7-I-20-HZ
APPLICATION FOR CERTIFICATE OF APPROPRIATENESS

4002 Tazewell Pk.
Tazewell Pike NC-1

Staff Report - Certificate of Appropriateness Application

File Number: 7-I-20-HZ

RIGHT ELEVATION

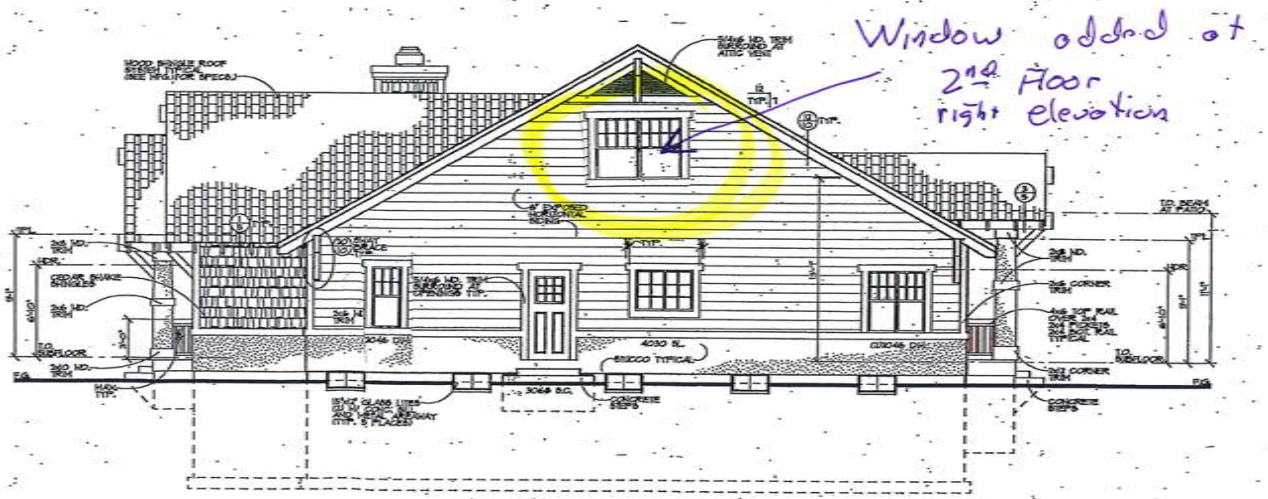
Modification to design of new construction approved by HZC in March 2020. Paired, double-hung, three-over-one windows proposed for second-story gable fields. Windows to be Pella Impervia brand, fiberglass windows to match previously approved design, with trim to match first-story windows.

1. The new house, including window specifications and placement, at 4002 Tazewell Pike was approved by the Knoxville Historic Zoning Commission at the March 2020 meeting.
2. Building codes require bedrooms to have a window to provide egress; the applicant is requesting the installation of paired windows on each side gable field. The paired windows will reflect the design, size, materials, and trim of the windows approved for the first story. The three-over-one, double-hung, fiberglass windows are appropriate for new construction built in the Craftsman style. Additional windows provide transparency and visual interest to the gable fields which were previously large swaths of siding.

Staff recommends approval of the work as proposed.

LEFT ELEVATION

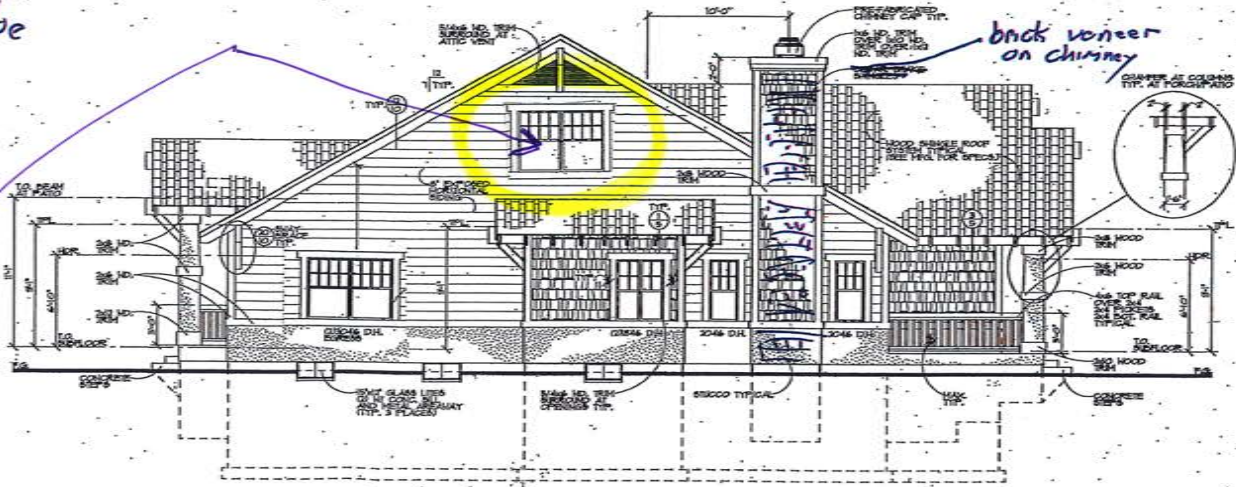
Window added at
2nd floor
left elevation
